## MANOR ISD ELEMENTARY SCHOOL #10

SP-2022-0095CX

Tunde Daramola Environmental Review Specialist Senior Development Services Department

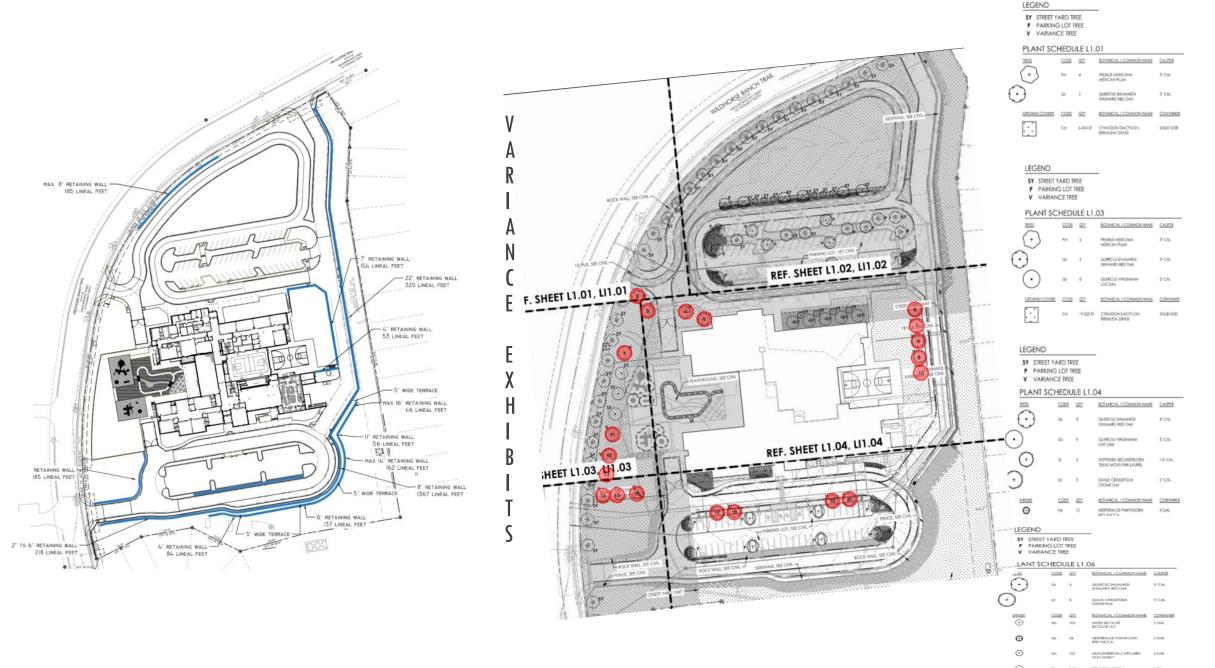
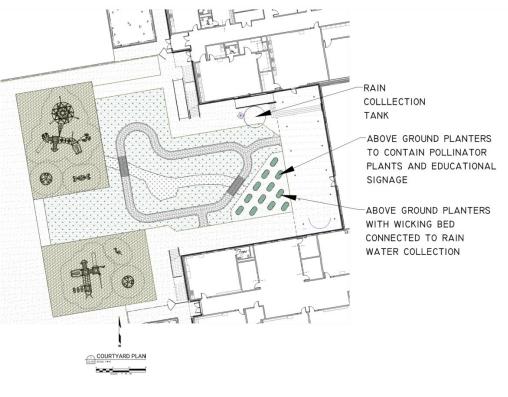
Staff recommends the variance, having determined that the required findings of fact have been met.

Staff also recommends and supports the following conditions in accordance to approved variance exhibits:

- Provide structural containment of fill with a terraced retaining wall where applicable.
- Increase tree inches on site by adding 20 native trees over the required number of trees.
- Provide pollinator plants along with educational signage for the kids.
- Use rainwater harvesting on site.
